Access Compliance Report

Public Rights-of-Way

| Intersection ID: 6255 | Main Street: HOOVER_DR | Cross Street: NEVIN_RD | Location: SW |
| ADA ID: 3A254D220E79 | Ramp Type: Perp | Initial Pass/Fail: Fail | Overall Compliance: No |

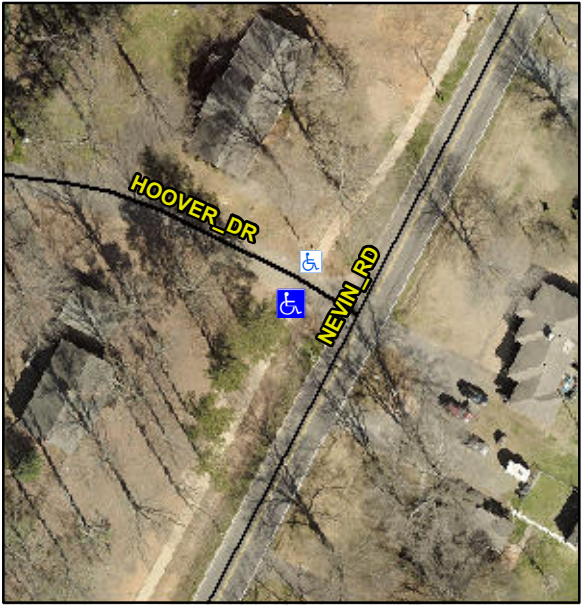
| Codes/Mitigation Info/Possible Solution | | | Field Measurements/Component Compliance | | |
|--|--|--|---|-----------------------------|-------------|
| | Remove & Replace Entire Ramp. | | Yes | Ramp Length (in) | 73.0 |
| <p>Surveyor Notes:</p> <p>N/A</p> <p>PROW/ADA:</p> <p>R304.5.3</p> | | | N/A | DWS Contrast? | N/A |
